ISSUE: Request for revisions to previously approved plans to Demolish/Capsulate and for Alterations at 10 Duke Street

LOCATION: 10 Duke Street (formerly 2 Duke Street, building A)

STAFF RECOMMENDATION

**BAR #2019-00216 & BAR #2019-00217**
10 Duke Street

Figure 1: Image of the west elevation of 10 Duke in 2017 showing the variety of existing window types and masonry coatings to be removed.

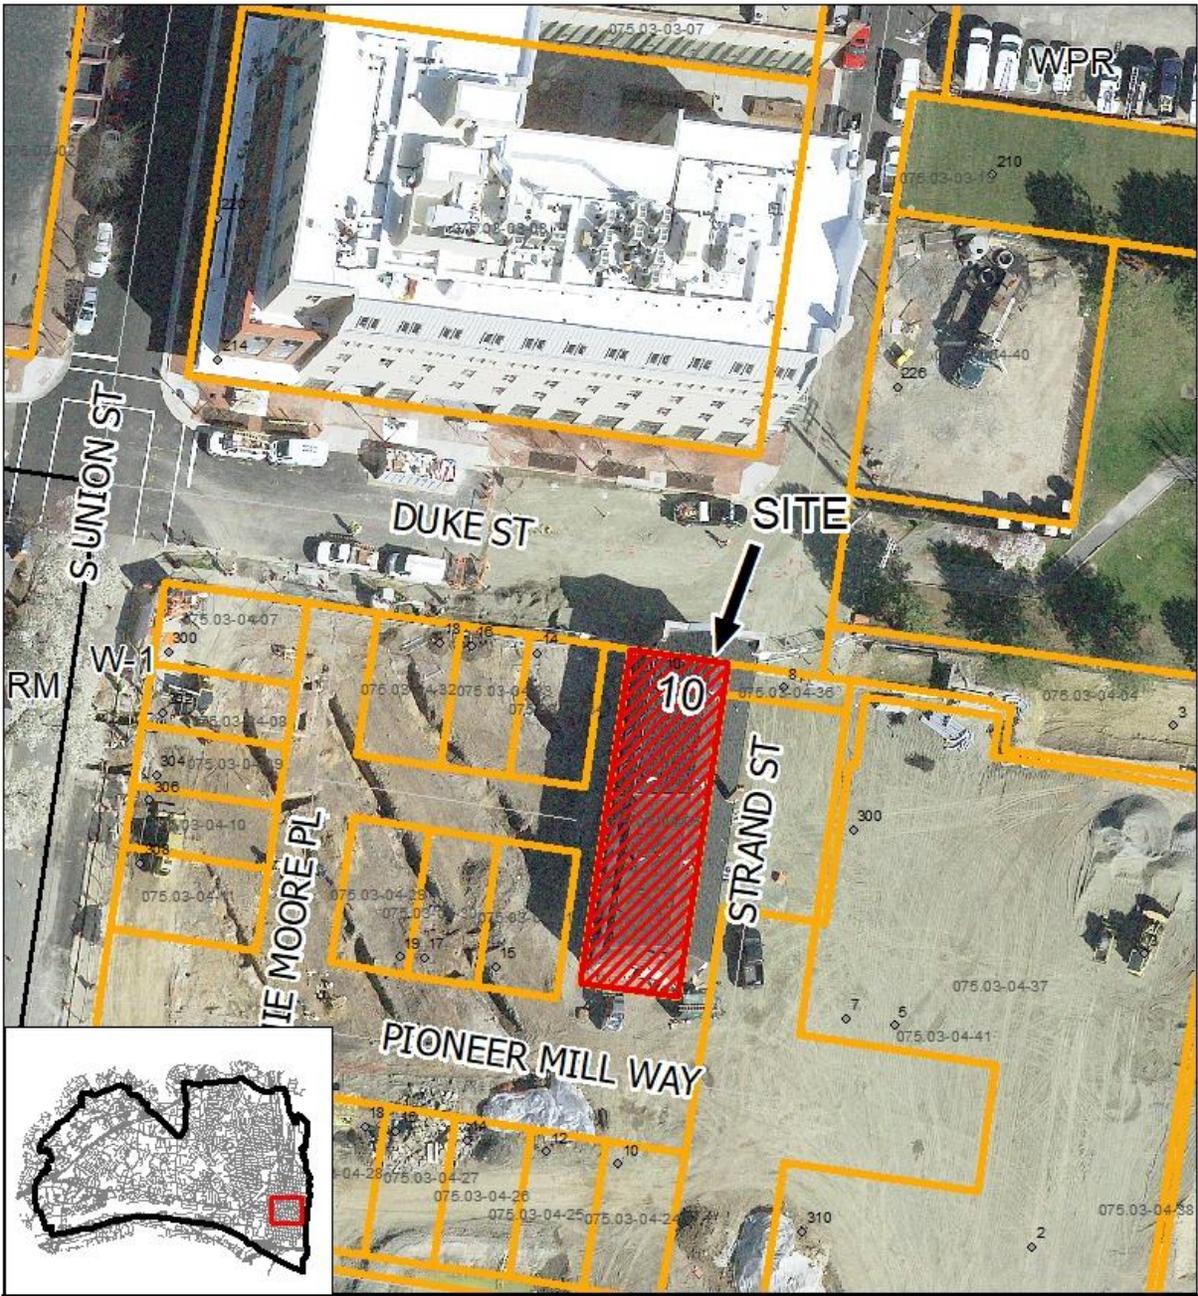
In addition, as is clear on the application drawings for the previous demolition approval, much of the exterior wall material would have to be reconstructed in order to accommodate the new and recreated window openings. Tests to clean paint and tar that had been applied to the wall over the years were not entirely successful and many bricks were suffering from rising damp and the effects of inappropriate Portland cement repointing. (Figure #1) The structural engineers expressed

1 NORTH ELEVATION
A33 1/8"=1'-0"

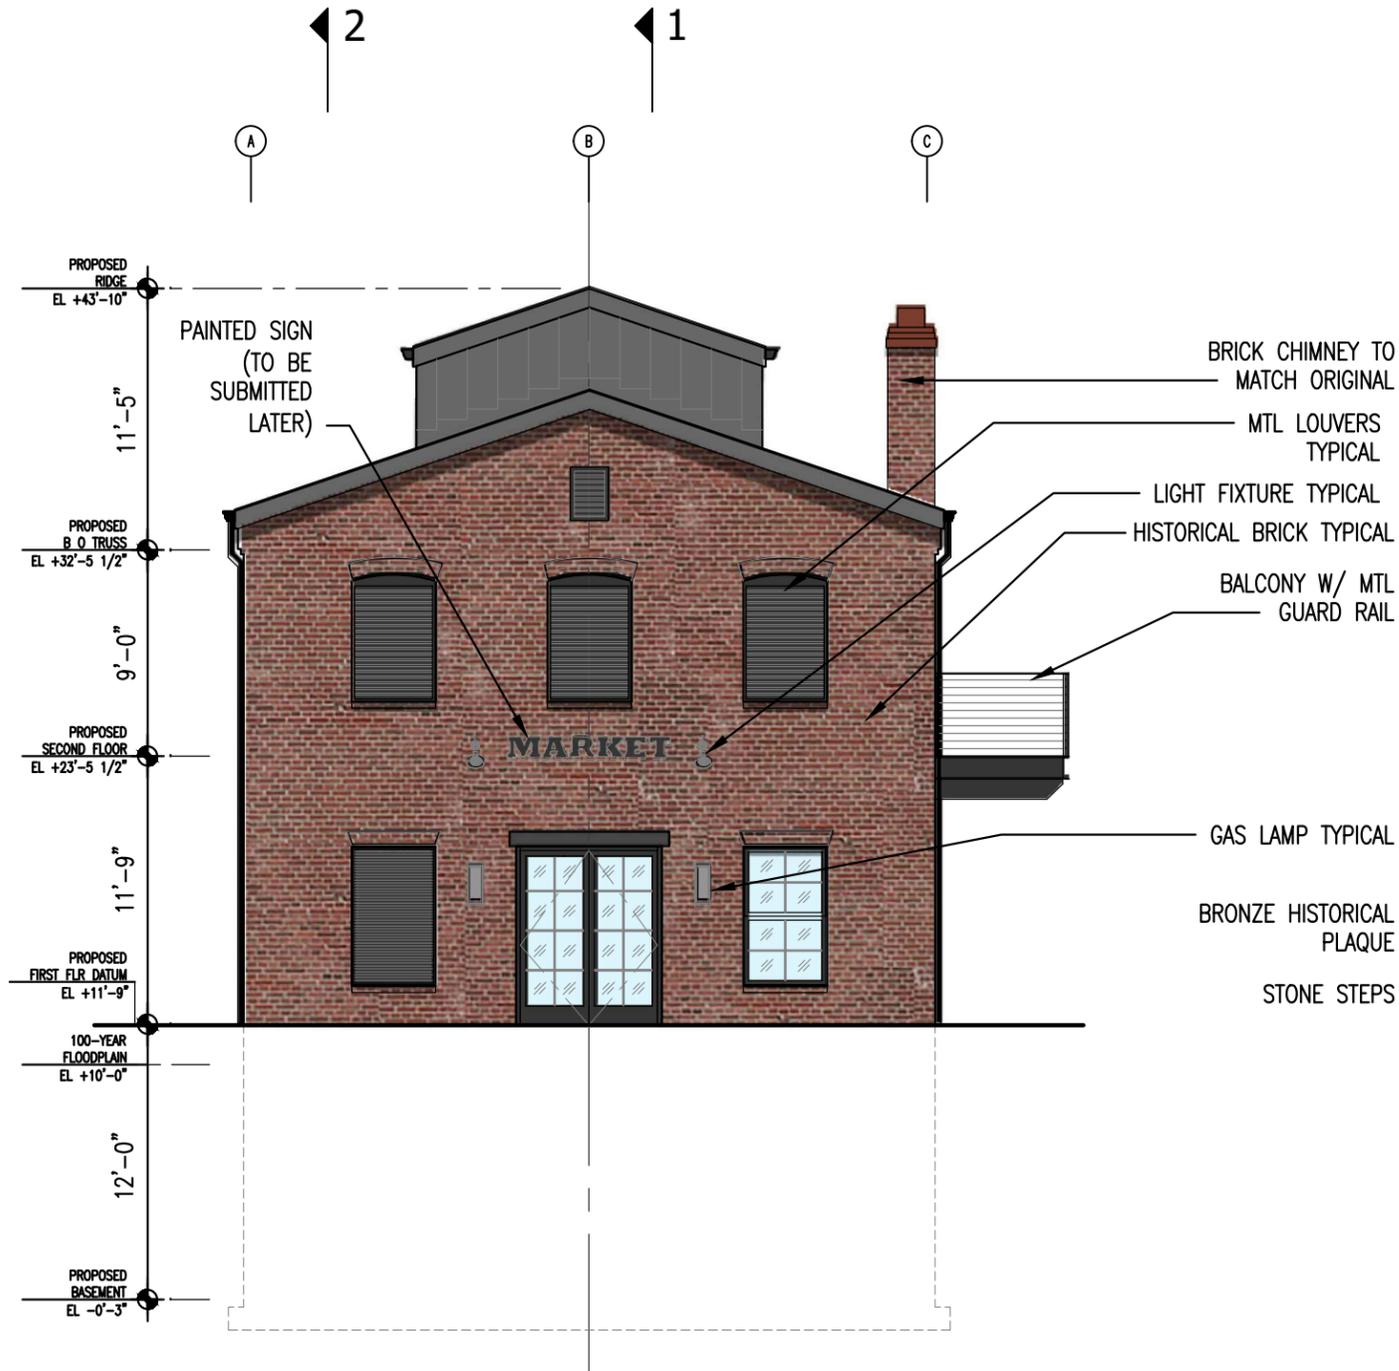
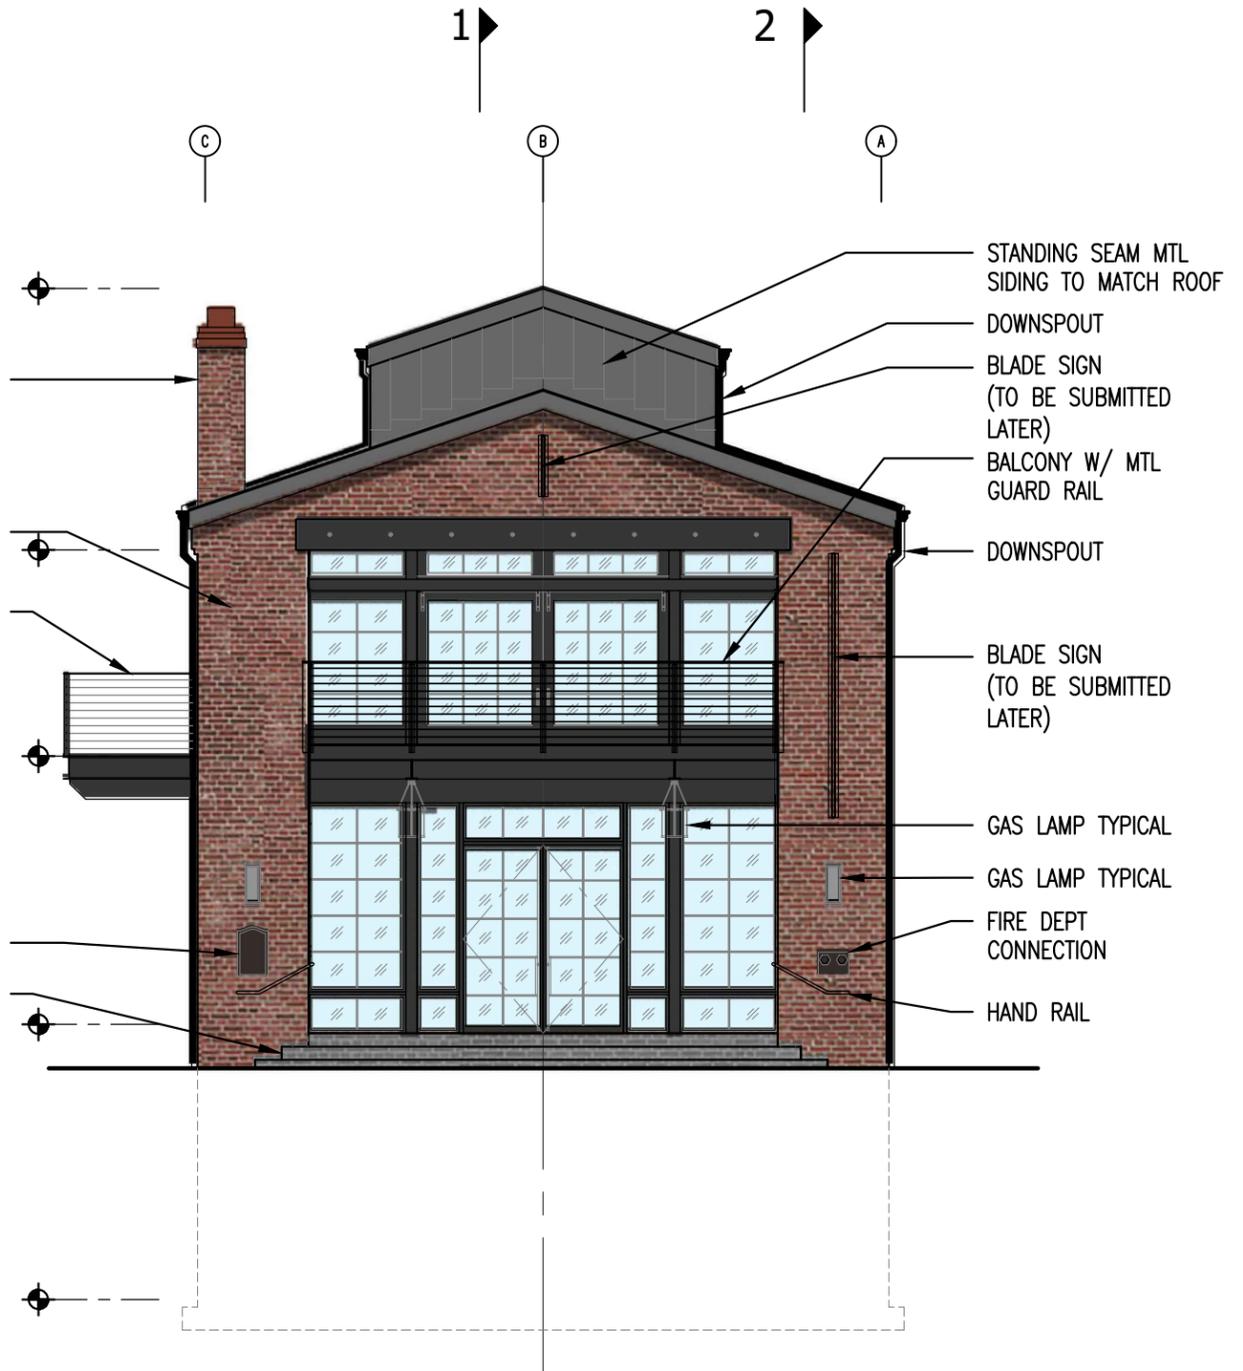
3. Staff strongly supports the enlarged glass façade on the north elevation. It recalls some of the large loading doors for some of the industrial uses, including aircraft manufacturing, historically located on the site. However, while the applicant understandably wants as much light into and views from the interior as possible, the height of the opening creates

visually weak corners where the masonry gable end wants to sit completely on the masonry piers below in a load-bearing masonry building. Staff recommends that the tiny transom window above the doors on the second floor be eliminated and the steel beam supporting the gable end be lowered slightly so that the masonry gable end and piers are more visually and physically connected. A vent/window could then be provided as a feature element in the gable end, as at the south gable end, in lieu of the small sign shown.

8. Lower the steel lintel above below the north masonry gable approximately one foot.
9. Incorporate historic interpretation in the form of a plaque or marker that relates specifically to this historic warehouse, using the same design and materials as the approved Robinson Landing historic interpretation.
